1 Q. At page vi of the Hydro report "Upgrade Transmission Line Corridor" dated April 28,
2 2014, Hydro states that the new transmission line will provide "...the *required*
3 *reinforcement to maintain the stability of the system to ride through contingencies*
4 *planned for within the planning criteria.*" Has Hydro commissioned any independent
5 review of the appropriateness of its planning criteria, in relation to this project? If
6 so, please provide a copy of the review report.

Review of the Muskrat Falls and Labrador Island HVdc Link and the Isolated Island Options

Prepared for:
Hon. Jerome Kennedy, Q.C.
The Minister of the Department of Natural Resources
Government of Newfoundland and Labrador

Prepared by:
Manitoba Hydro International Ltd.
211 Commerce Drive
Winnipeg, Manitoba R3P 1A3, Canada
www.mhi.ca

Figure 8: Typical HVdc Transmission Guyed Tangent Structures which comprise approximately 85% of the towers in the Labrador-Island HVdc transmission line

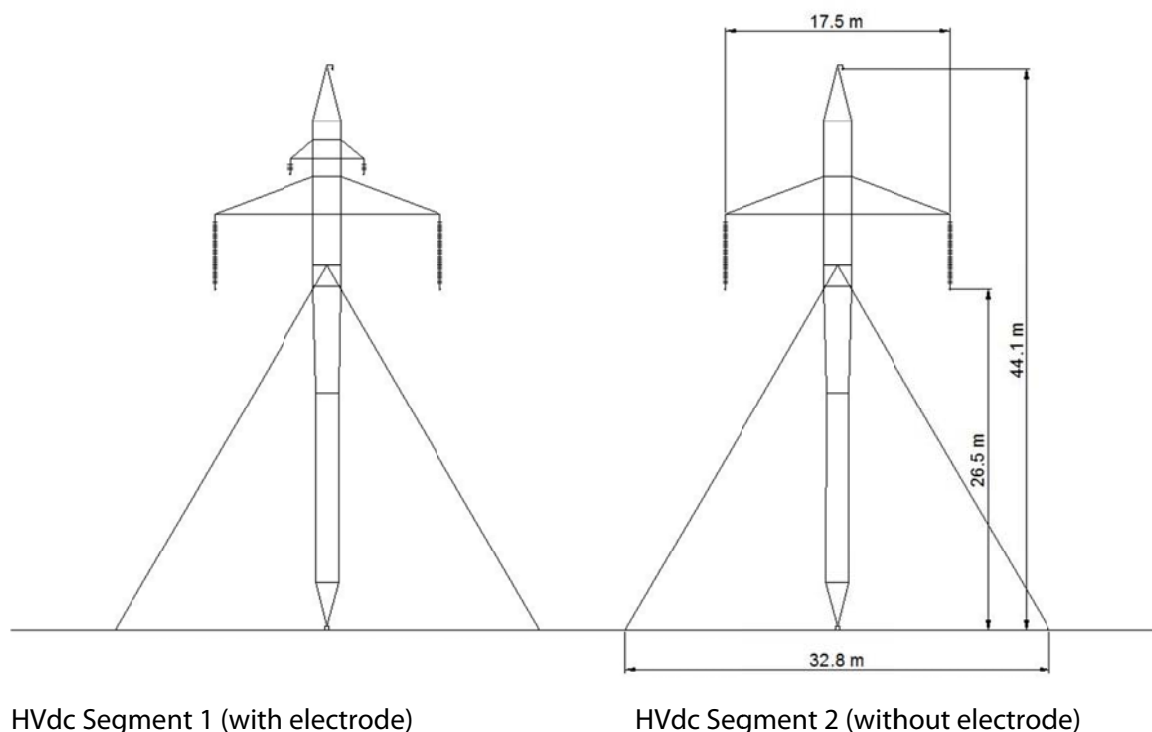
Engineering work is in progress to complete the detailed design for the HVdc line. Nalcor has defined 12 structure families, with a total of 25 structure types, required to economically construct the line. Wherever possible, an effort was made to use common structures in the various loading zones in an effort to minimize the number of unique, custom structures which mitigates design and construction cost.

Nalcor's design controlled the structure loading from the various ice-and-wind loading combinations by reducing or increasing the ruling span in the 11 weather-zone regions. Generally, as the loading increased, the design ruling span and conductor tension was

Figure 9: Climatic Ice Loads along the HVdc Transmission Line Route compared to the CSA Standard 1:500-year return period limit

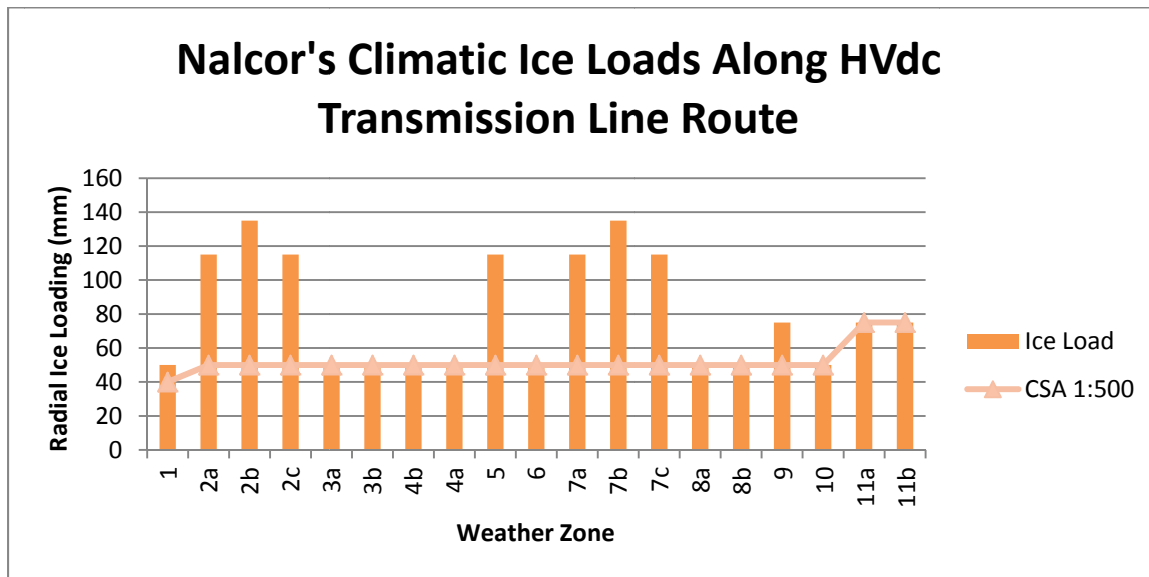
MHI finds Nalcor has completed a thorough assessment of the various climatic regions impacting the ± 350 kV HVdc line from Muskrat Falls to the Soldiers Pond transmission line route. In documents provided by Nalcor to MHI, the meteorological research determined that 11 zones along the route corridor with a number of subzones, each with a unique zone-specific climatic loading is required to reliably predict climatic loading to the transmission line (see Figure 9).

The climatic loadings for each line section were selected based on Nalcor’s past research studies and statistical analysis of the climate data. Extreme values based upon historical data and observations on ice accumulation and wind speed were implemented in the line regions through the Long Range Mountains and other regions in Labrador. This follows the recommendations of CAN/CSA A.7.2 where designers are cautioned to investigate and design for areas with localized higher icing and/or wind forces. It is MHI’s opinion Nalcor undertook appropriate due diligence selecting the weather loads for this transmission line.

Nalcor’s research studies to define the climatic loadings along the transmission line route were based on 50 years of data, as outlined in the document “Muskrat Falls Project – Exhibit 97, Appendix A Revision 1”. The climatic loadings for each line section are approximately equivalent to the climatic loadings calculated assuming Canadian Standards Association (CSA) 1:500 year-return period.

MHI notes that CAN/CSA C22.3 suggests a greater reliability of design to 1:150-year or 1:500-year return periods for lines of voltages greater than 230 kV which are deemed of critical importance to the electrical system. It is MHI’s opinion the ±350 kVdc and 315 kV ac lines proposed for the Lower Churchill Project be classified in a critical importance category due to their operating voltage and role in Nalcor’s long term strategic plan for its transmission system and be designed to a reliability return period greater than 1:50 years.
